Access Compliance Report Public Rights-of-Way (Curb Ramps)

Main Street: TIGERTAIL_DR Cross Street: CHRISTY_LN Location: SE

ADA ID: RPRK211207130543 Ramp Type: Type 1 - Perpendicular Diagonal Initial Pass/Fail: Pass Overall Compliance: No Severity Score: 0

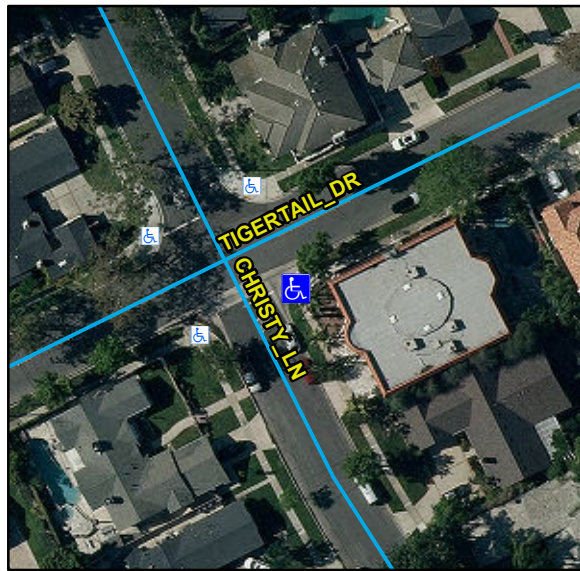
R304.2.1, R304.5.3, STD 1115

Remove & Replace Landing.
